Access Compliance Report

Public Rights-of-Way

(Curb Ramps)

Intersection ID: 12401	Main Street: MIDWOOD_PL	Cross Street: TIPPAH_AV	Location: NE
ADA ID: 866C1A76CAFD	Ramp Type: Perp	Initial Pass/Fail: Fail	Overall Compliance: No
Severity Score: 13.75			
Codes/Mitigation Info/Possible Solution		Field Measurements/Component Compliance

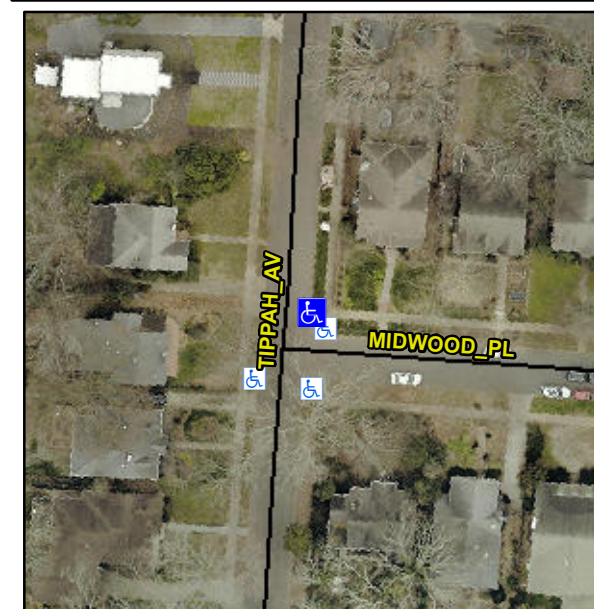
Not Found, R304.2.2, R304.5.3

Compliance	Description	Data	Compliance	Description	Data
N/A	Ramp Length (in)	65.0	No	Ramp Slope (%)	9.3
Yes	Ramp Width (in)	48.0	No	Ramp XSlope (%)	4.5
N/A	Flare Type LT	N/A	N/A	Flare Type RT	N/A
N/A	Flare Slope LT (%)	N/A	N/A	Flare Slope RT (%)	N/A
N/A	Flare Traversable LT?	N/A	N/A	Flare Traversable RT?	N/A
N/A	Landing Length (in)	N/A	N/A	DWS Provided?	N/A
N/A	Landing Width (in)	N/A	N/A	DWS Contrast?	N/A
N/A	Landing Slope (%)	N/A	N/A	DWS Length (in)	N/A
N/A	Landing X Slope (%)	N/A	N/A	DWS Full Width?	N/A
N/A	Landing Curb? (Y/N)	N/A	N/A	DWS Offset (in)	N/A
N/A	Shared Landing?	N/A			
N/A	Gutter Ponding?	N/A	N/A	Gutter Slope (%)	N/A
N/A	Gutter Lip Ht (in)	1.0	N/A	Gutter X Slope (%)	N/A
N/A	Painted X Walk1?	No	N/A	Painted X Walk2?	N/A
	X Walk 1 Direction	To W		X Walk 2 Direction	N/A
N/A	X Walk 1 Width (in)	N/A	N/A	X Walk 2 Width (in)	N/A
	X Walk 1 Slope (%)	1.6		X Walk 2 Slope (%)	N/A
	X Walk 1 X Slope (%)	3.6		X Walk 2 X Slope (%)	N/A

N/A	Ramp inside XWalk1?	N/A	N/A	Ramp inside XWalk2?	N/A
	Road Slope (%)	N/A	N/A	Clear Space?	N/A
	Road X Slope (%)	N/A	N/A	Clear Space to XWalk (in)	N/A
N/A	Any Obstructions?	N/A	N/A	Storm Grate/Utility Hazard?	N/A
	Obstruction Type			Storm Grate/Utility Type	
		N/A			N/A
		Yes		Surface Condition? (G/P)	Good

Remove & Replace Entire Ramp.
